VILLAGE OF LOMBARD
REQUEST FOR BOARD OF TRUSTEES ACTION
For Inclusion on Board Agenda

SUBJECT: ZBA 23-02: 1161 S. Finley Road

INTER-DEPARTMENTAL REVIEW COMMITTEE REPORT

1161 S. FINLEY ROAD

Figure 4. Side elevation showing deck and grade change.

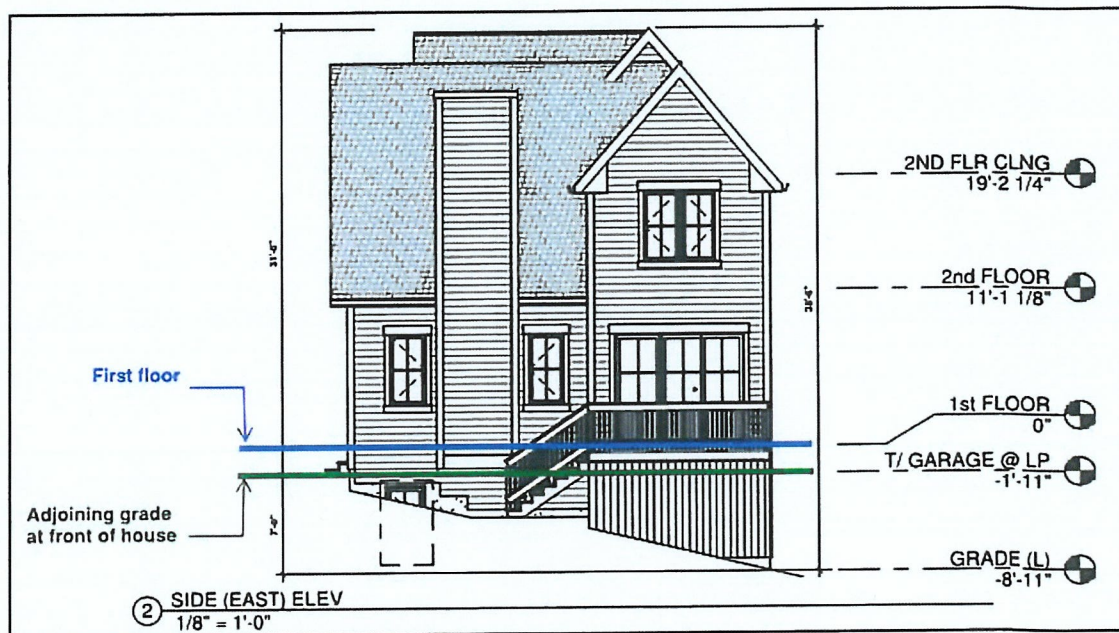
5. *Variation to allow decks more than three feet above average level of adjoining ground to encroach into front and rear yard setbacks*

The petitioner is proposing a deck on the side of each unit. These decks will encroach into the front and rear yard setback areas. Section 155.212 permits decks to encroach into the front and rear yard setbacks if the deck in question is not more than three feet above the average level of the adjoining ground, provided that a minimum two-foot side yard setback is maintained.

The subject property contains a significant downward slope away from Ann Street. Grade on the south side of the property is between 7 and 9 feet higher than it is on the north side of the property. The decks have been designed to be level with the first floor living space in the building. The decks and the first floor of the units are approximately three steps (roughly two feet) higher than the grade at the front entrance of the units. However, as measured from the level of the adjoining ground, the decks are between five and eight feet above grade due to the significant downward slope on the property (Figure 4). Staff recognizes the uniqueness of the topography of the property. Staff supports the requested variance for the decks.

SITE PLAN - CIVIL

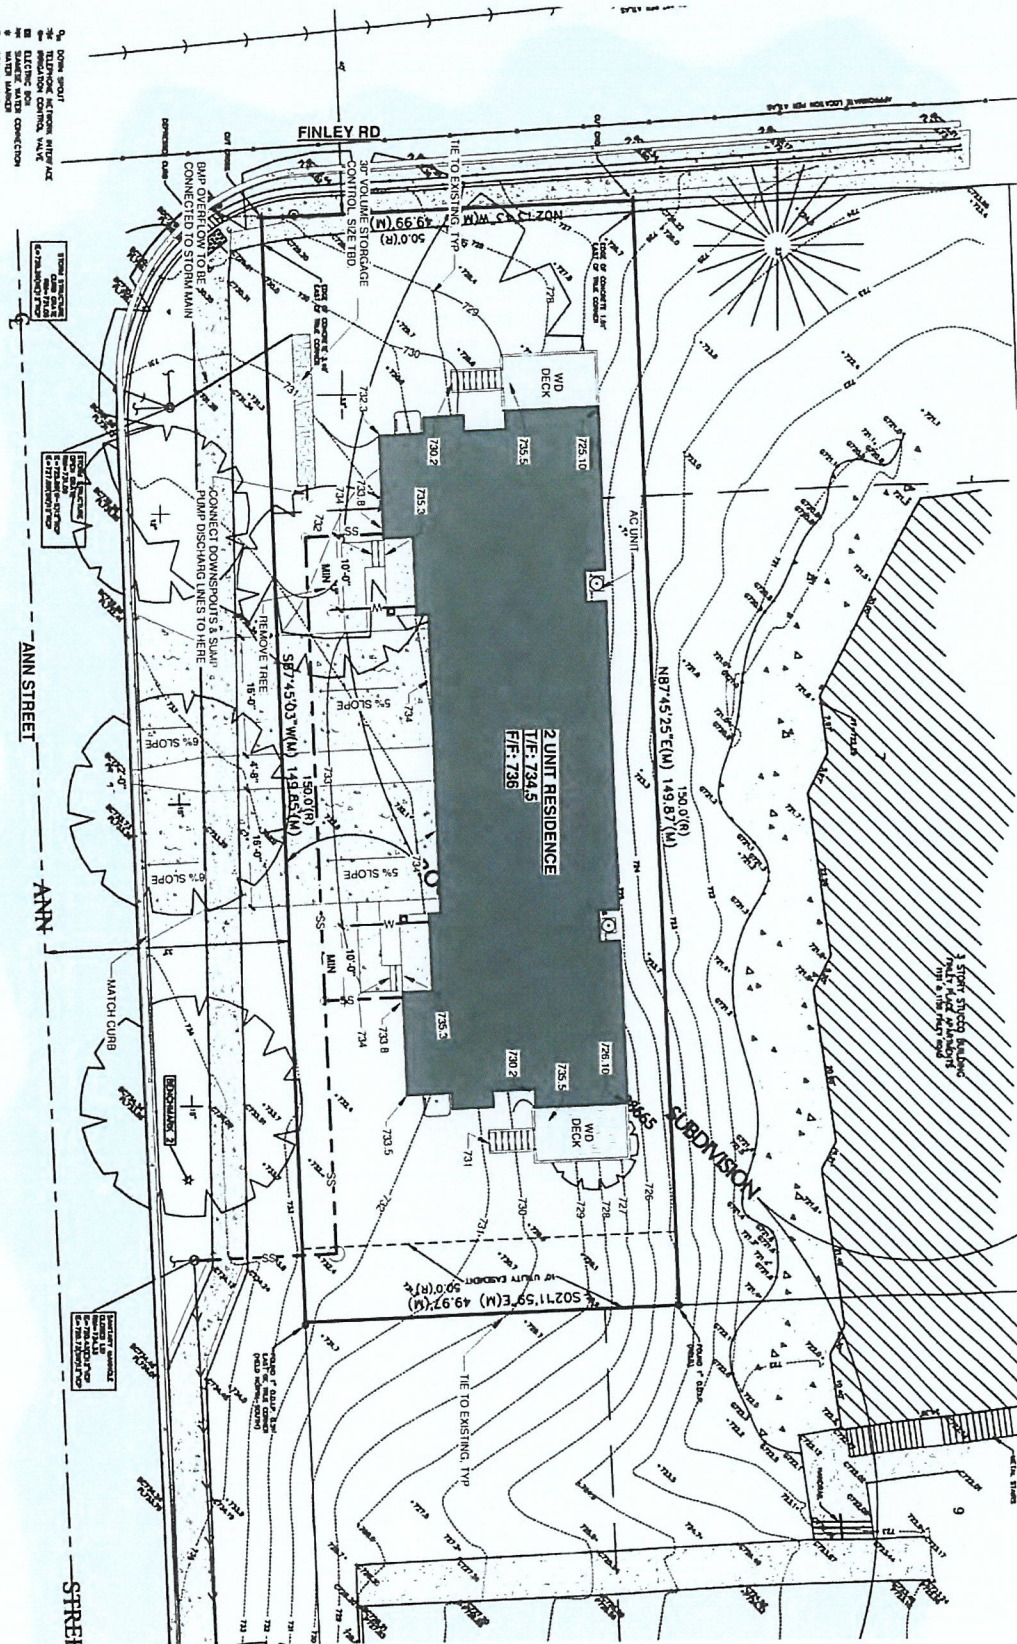
Private Engineering Services (PES) has the following comments regarding the petition. Additional comments may be forthcoming during permit review.

1. Sump pump discharges will need to directly connect to the Village storm sewer system.
2. BMP overflow must directly connect to the Village storm sewer system.
3. No additional runoff created by the new building will be permitted to flow to the adjacent properties (downspouts must be connected to pipes leading to the BMP, and all sidewalk/driveways must drain to the street).
4. A drainage and utility easement must be dedicated to the Village over the proposed sanitary sewer main (post-construction).

The Department of Public Works has the following comments regarding the petition. Additional comments may be forthcoming during permit review.

1. Two driveways will be allowed for the proposed development due to being infeasible to share one driveway.
2. The sanitary service lateral(s) shall extend directly into the private property from the sanitary sewer main in the public right-of-way rather than running down the parkway.
3. Sump pumps and the stormwater runoff (especially downspouts) shall be collected by a pipe system within the private property and then discharged into the Village's storm sewer near the southwest corner of the parcel.
